Level 2 Design and Visual Communication 2024

91338 Produce working drawings to communicate technical details of a design

THESE ARE RENDERS OF MY SPATIAL PROJECT (SMALL DWELLING 120 SQM)

BLOCK WINDOW JAMB

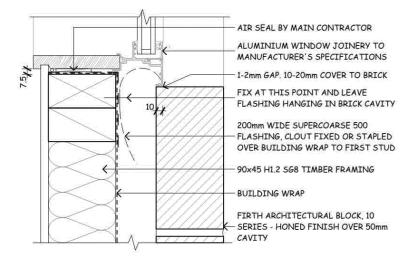
This set of drawings lacks informative and coherent information for Excellence due to errors with the details and accurate referencing of information. There are two details labelled as number 1, but each is in a different location and elevation. If labelled correctly they should also be showing significantly different information. The eave detail, number 3, should show weatherboard as the cladding, not brick. At the location indicated, the eaves/soffit area does not include the wall framing or cladding.
